ADDENDUM #1

Sylvan Union School District

Site Work for New Portables Group 1 – (3) Sites

BID NUMBER: 2023-24 #4

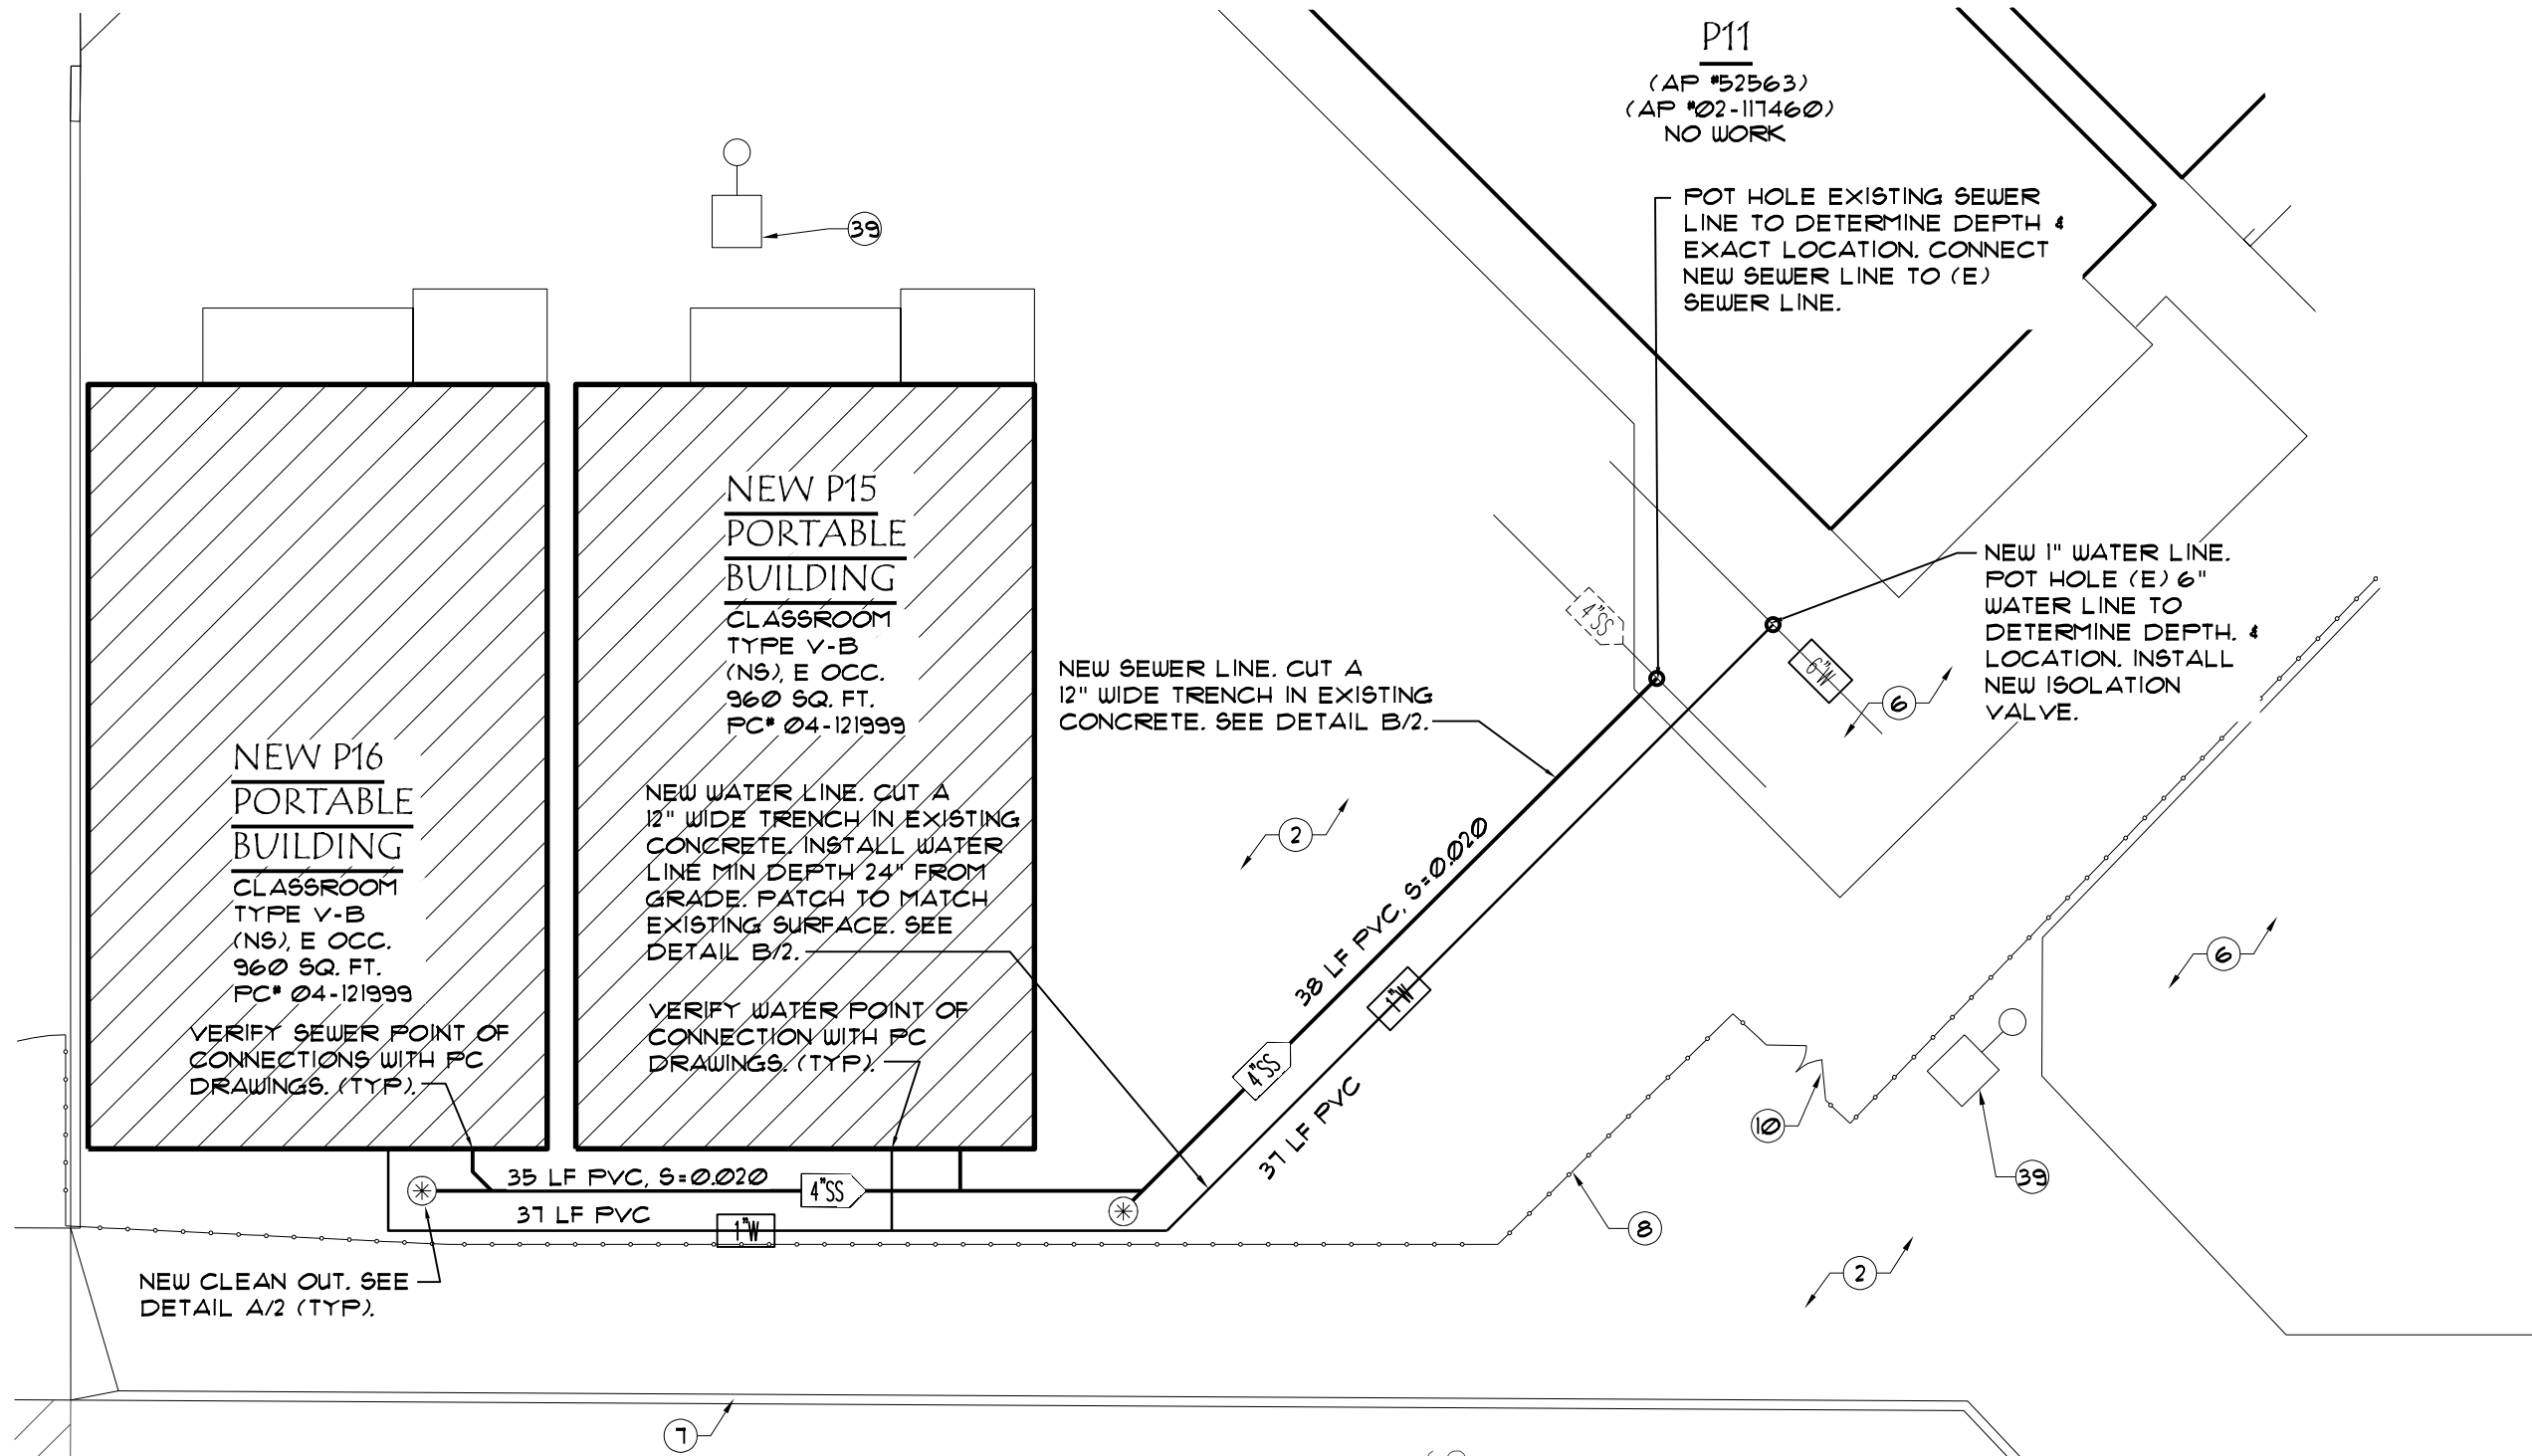
ITEM #1.0: Concrete Flatwork: New concrete section shall be 4.0” PCC with #3 bars @ 18” oc., centered in slab, over 6.0” Class II AB, over compacted native soil.

Note: Site Contractor shall install ½” expansion material (EJ), at the perimeter of new flatwork, fill joints with “sika flex”.

Note: Site Contractor shall provide “Expansion Joints” with ½” felt, in all flatwork at a maximum of 400 sf between joints (Field verify locations). All expansion joints shall be filled with “sika flex” and doweled with #3 bars at 18” centers.

PARTIAL PLUMBING SITE PLAN
 SCALE: 1" = 10'-0"

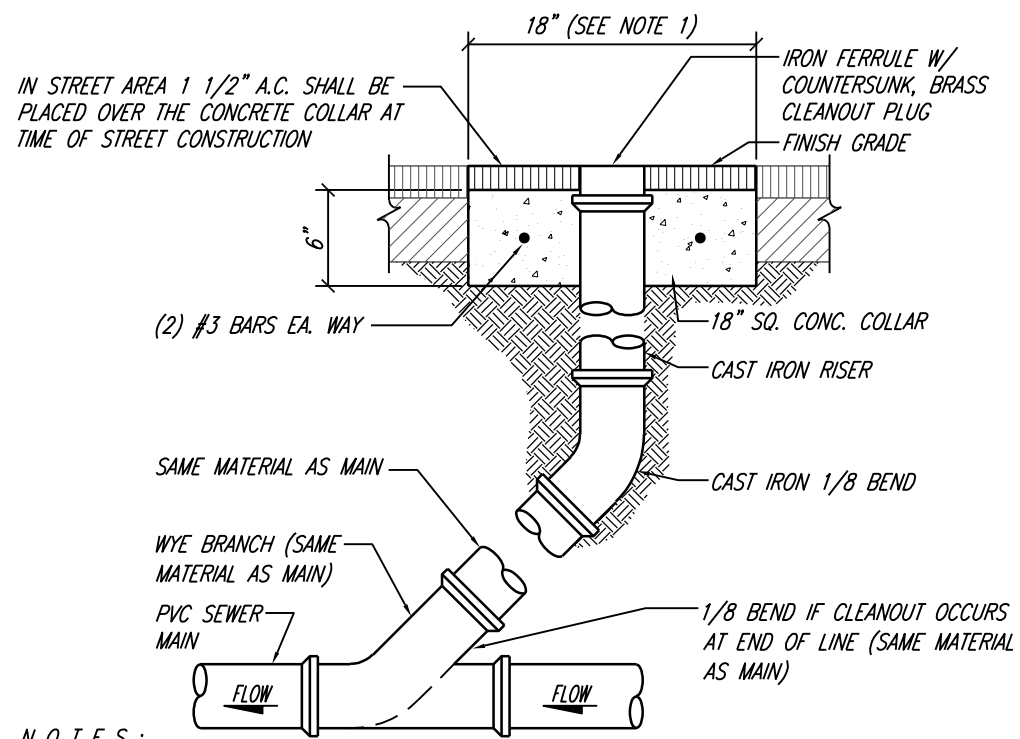
ITEM #1.1: Ustach Middle School – Water & Sewer Service: Provide new water and sewer service to new portables. See attached exhibit.

FOT HOLE EXISTING SEWER LINE TO DETERMINE DEPTH & EXACT LOCATION. CONNECT NEW SEWER LINE TO (E) SEWER LINE.

NEW 1" WATER LINE. FOT HOLE (E) 6" WATER LINE TO DETERMINE DEPTH & LOCATION. INSTALL NEW ISOLATION VALVE.

NEW SEWER LINE. CUT A 12" WIDE TRENCH IN EXISTING CONCRETE. SEE DETAIL B/2.

NEW WATER LINE. CUT A 12" WIDE TRENCH IN EXISTING CONCRETE. INSTALL WATER LINE MIN DEPTH 24" FROM GRADE. PATCH TO MATCH EXISTING SURFACE. SEE DETAIL B/2.

DETAIL "B" - TRENCH PATCH
 NTS

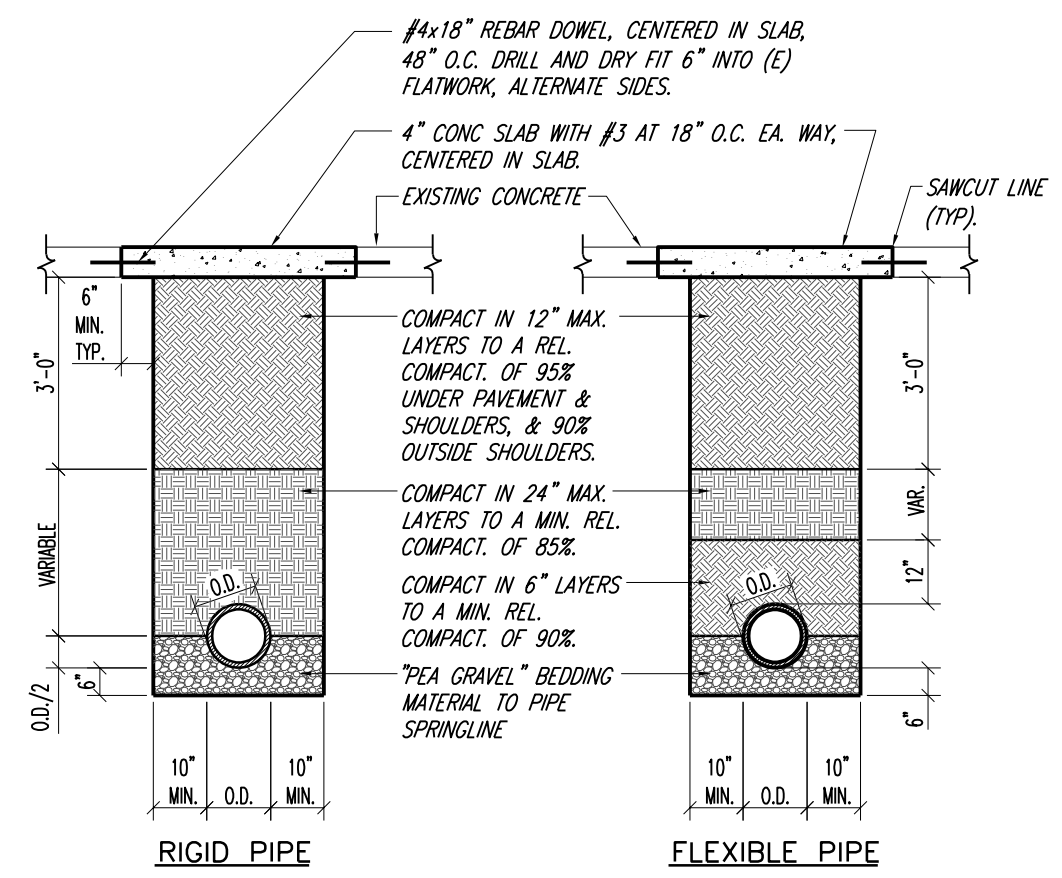
NOTES:
 1) CONCRETE COLLAR NOT REQUIRED WHEN VALVE BOX IS LOCATED IN CONCRETE SIDEWALK AREA.
